STATE OF NORTH CAROLINA
DEPARTMENT OF TRANSPORTATION

Subject: DCM Consistency for the proposed US 70 Havelock Bypass in Craven County. TIP No. R-1015. WBS 34360.1.2.

The North Carolina Department of Transportation (NCDOT) submitted additional information on Havelock Bypass to you on March 13, 2020 for review in regards to the Division of Coastal Management's CAMA Consistency Determination for the project. This package included supplemental information and revised permit drawings. Based on further coordination with the NC Division of Water Resources, further revisions need to be made to this request. This letter is a revised version of the March 13, 2020 request, showing additional and modified information highlighted in red.

PERMIT DRAWING
SHEET 102 OF 167

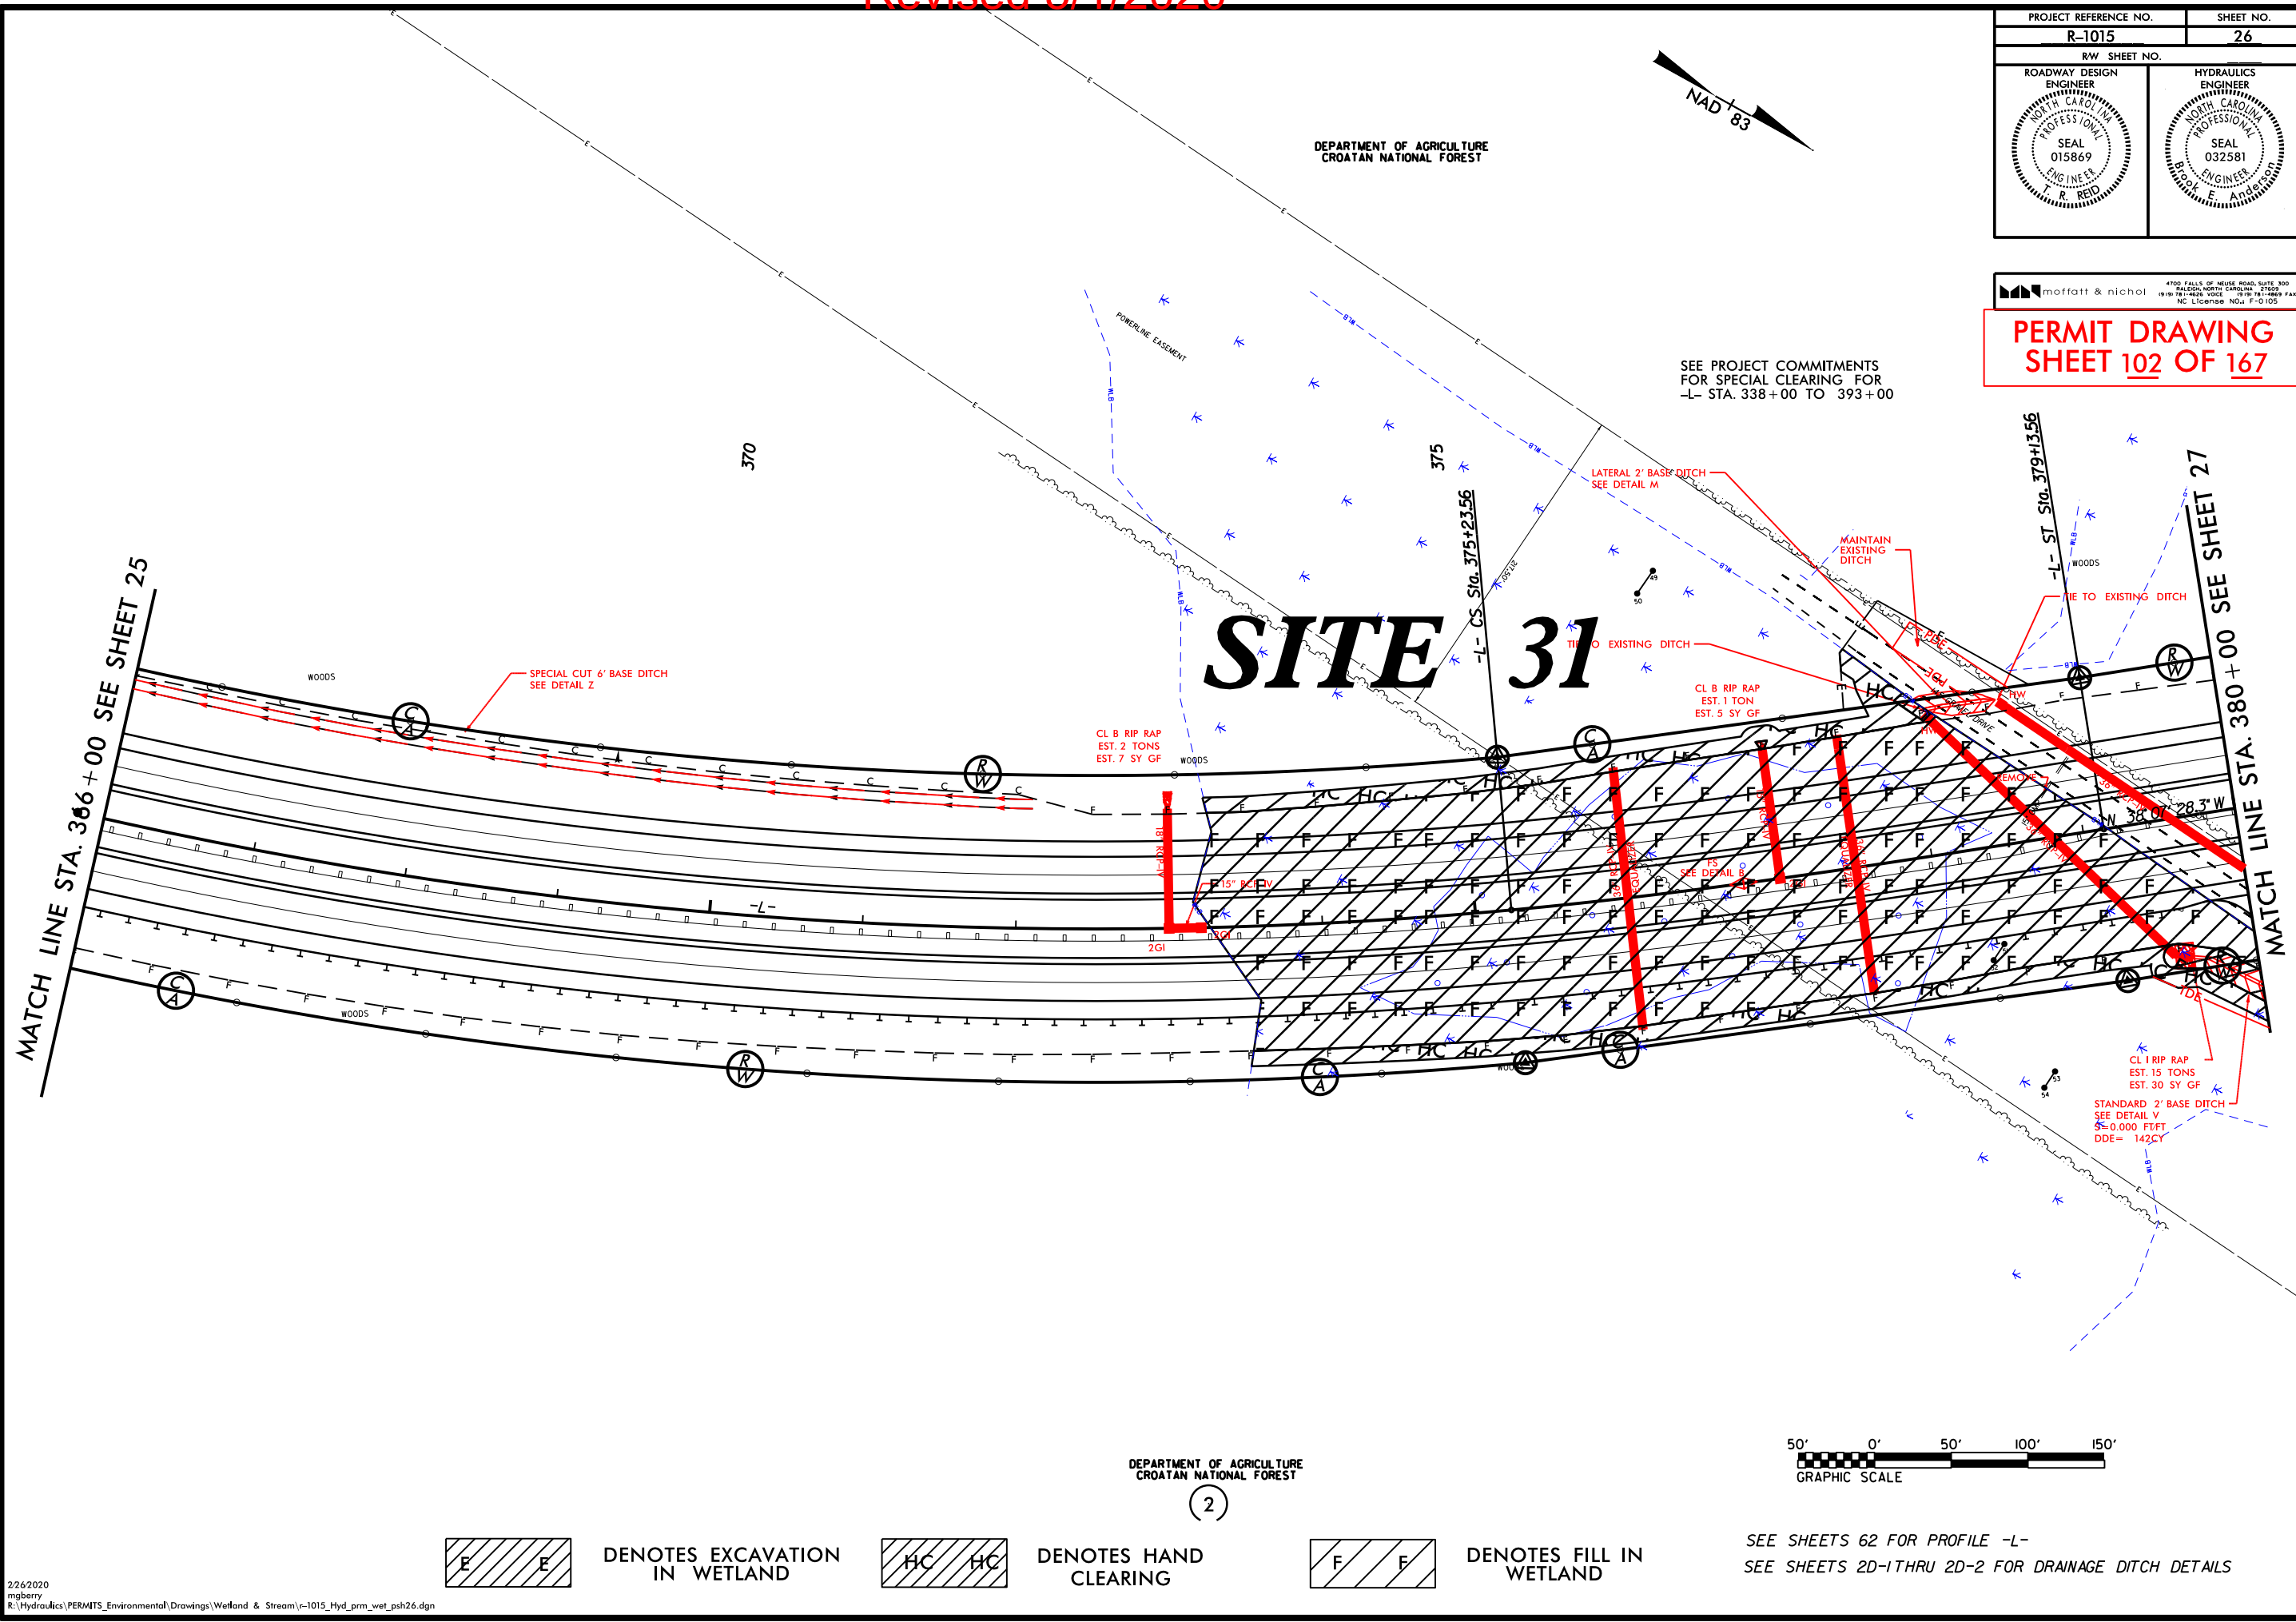
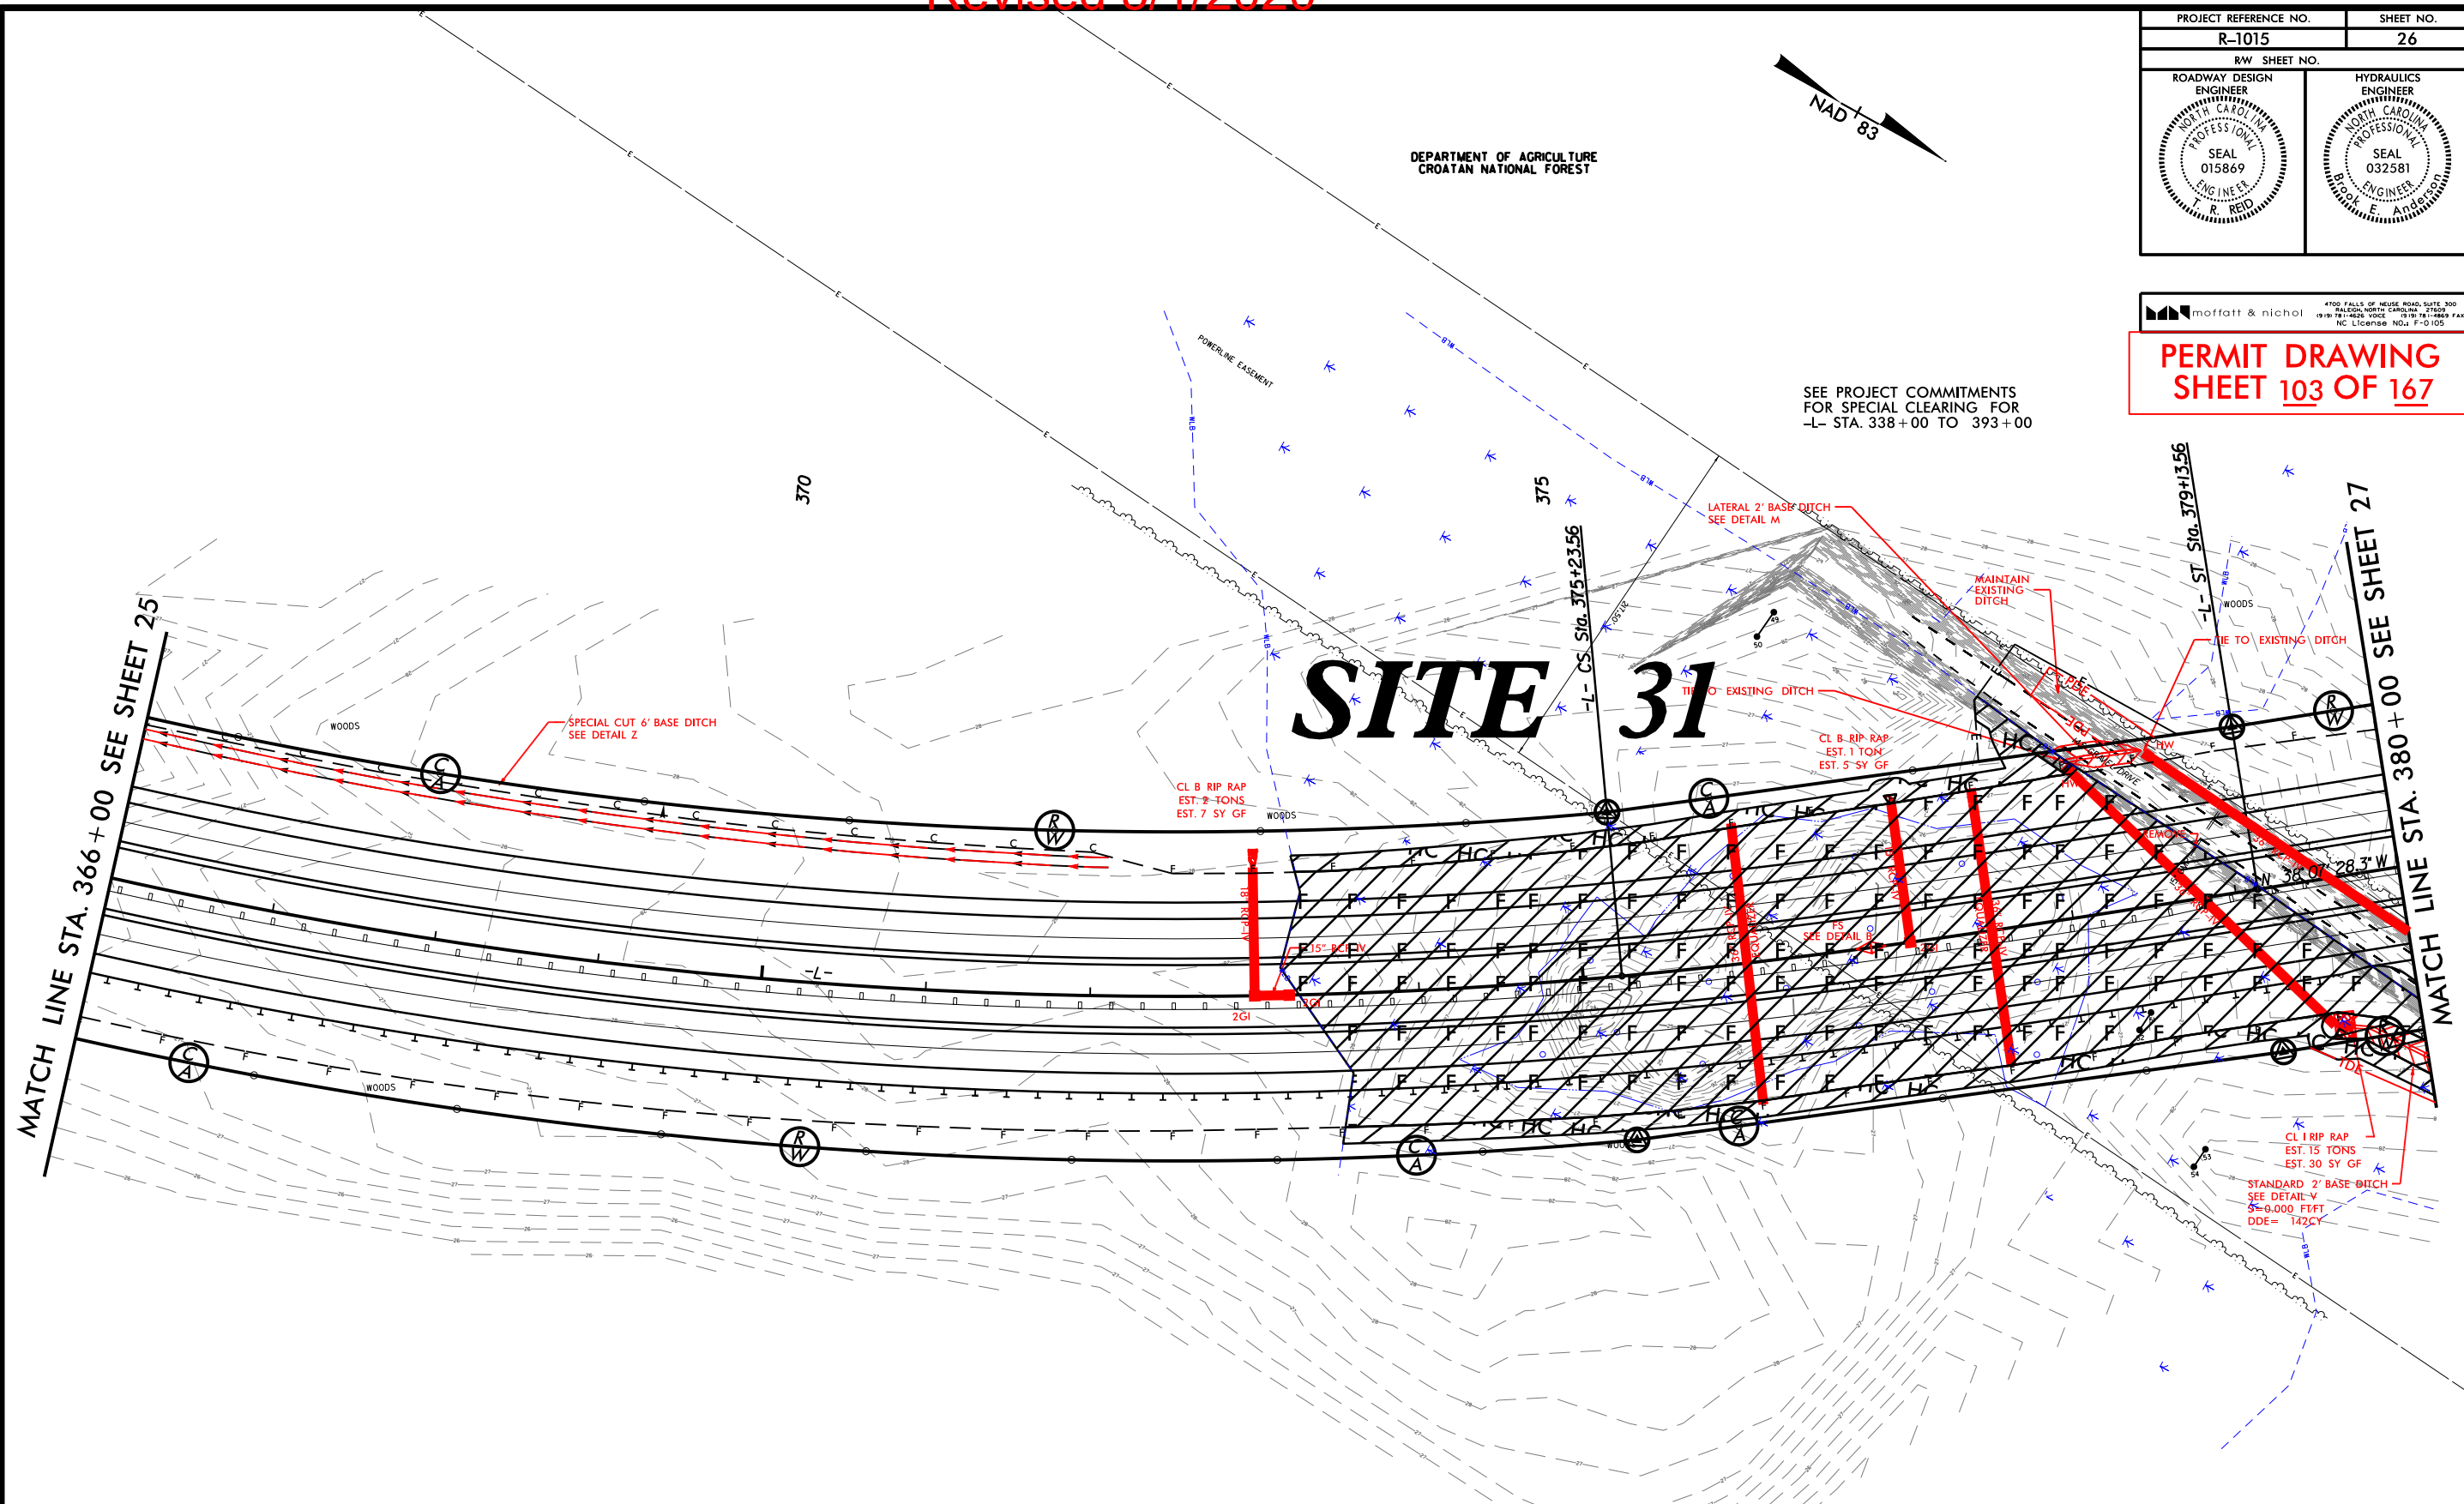
- Actual Excavation in Wetlands increase by 0.0265 acre (new = 0.079 acre, old = 0.053 acre)
- Site 31: omitted in 3/12/20 modification request (permit sheets 102 & 103). Access drive was removed. Fill in wetlands reduced by 0.01 acre. Excavation in Wetlands reduced, but the reported amount did not change.

- Fill in Wetlands (new = 2.2231 acre, old 2.2289 acre)
 - Excavation in Wetlands (new = 0.068 acre, old 0.072 acre)
- Site 47, (permit sheets 142 & 143) pipe shortened to eliminate easement on property, HW added. “Temporary Impacts in Surface Water” reduced by 0.01 ac. “Existing Channel Impacts Temp.” reduced by 10’.
